Supplement to the Parks and Recreation Resources Technical Memorandum

PREPARED FOR: Colorado Department of Transportation
PREPARED BY: Kelly Fredell, PE/CH2M HILL
COPIES: Andrea Garcia/CH2M HILL, File 187824_US_24_Corridor
DATE: November 18, 2011

The Colorado Department of Transportation (CDOT) is conducting an Environmental Assessment (EA) for changes to a 4-mile portion of US 24 between Interstate 25 and Manitou Springs. The parks and recreation resources in the corridor under evaluation in the EA were initially addressed in the *US 24 West Environmental Assessment: Park and Recreation Resources Technical Memorandum* (CH2M HILL, 2010). Since the initial analysis was completed for the *US 24 West Environmental Assessment: Park and Recreation Resources Technical Memorandum* (CH2M HILL, 2010), information regarding Vermijo Park and the Midland Trail has changed. This supplement analyzes and addresses these changes.

EXHIBIT 1 Proposed Action

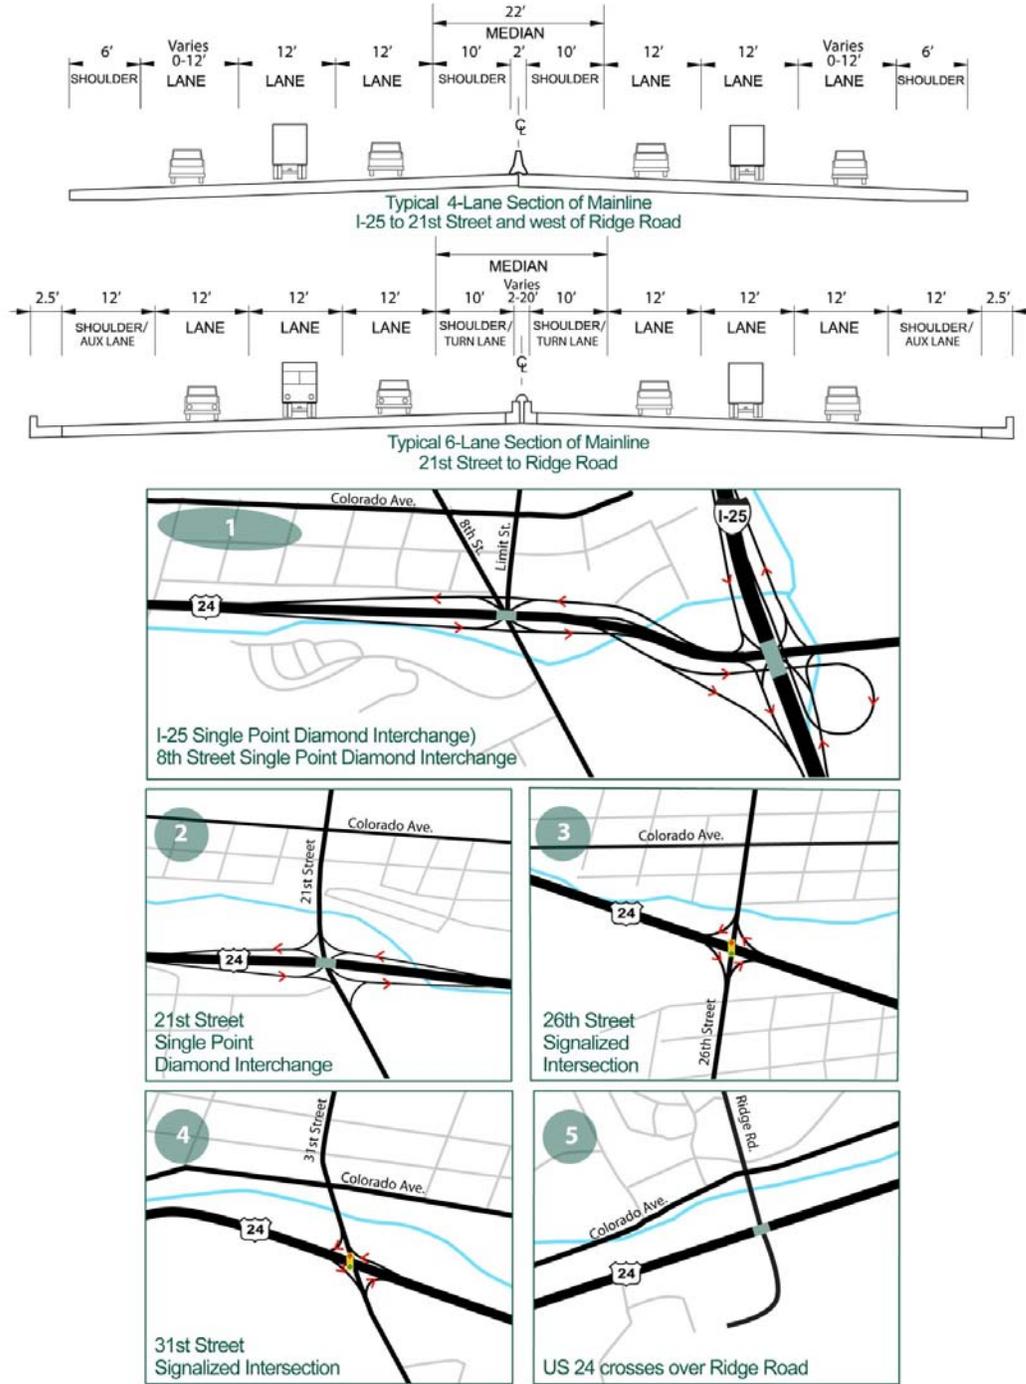
The following graphic supersedes Exhibit 1 in the *US 24 West Environmental Assessment: Park and Recreation Resources Technical Memorandum* (CH2M HILL, 2010).

EXHIBIT 2
Midland Trail

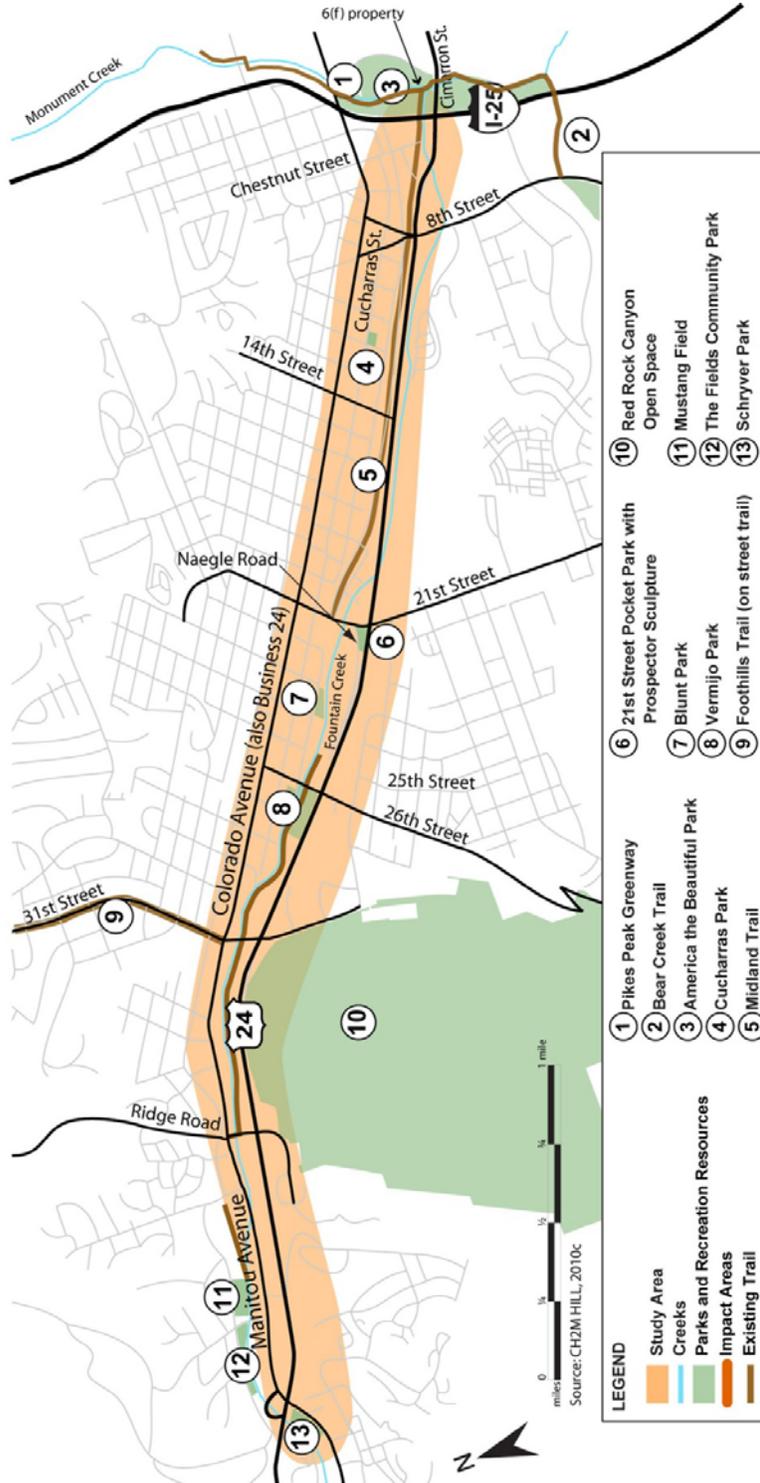
The following graphic supersedes Exhibit 2 in the *US 24 West Environmental Assessment: Park and Recreation Resources Technical Memorandum* (CH2M HILL, 2010).

In addition to the 0.3 miles of impacts identified between 8th Street and 11th Street in the *US 24 West Environmental Assessment: Park and Recreation Resources Technical Memorandum* (CH2M HILL, 2010), new impacts from the Proposed Action have been identified on the new Midland Trail segments constructed in 2011. Bridges will be replaced at the cross streets of 21st Street, 26th Street, 31st Street, and Ridge Road, causing a temporary construction impact to the trail in the vicinity of each bridge. No long-term impacts are expected at these four trail locations and the continuity of the trail during construction will be maintained.

These four temporary impacts areas total approximately 0.2 miles of the Midland Trail. The new Midland Trail is shown in Exhibit 2 in relation to the proposed improvements to US 24, 21st Street, 26th Street, 31st Street, and Ridge Road. For the safety of trail users, the trail will have to be temporarily relocated during the construction of the bridges over Fountain Creek and a new permanent trail will be constructed as part of each bridge improvement. Once construction is completed, users will be able to cross under each bridge on newly constructed trail at these locations.
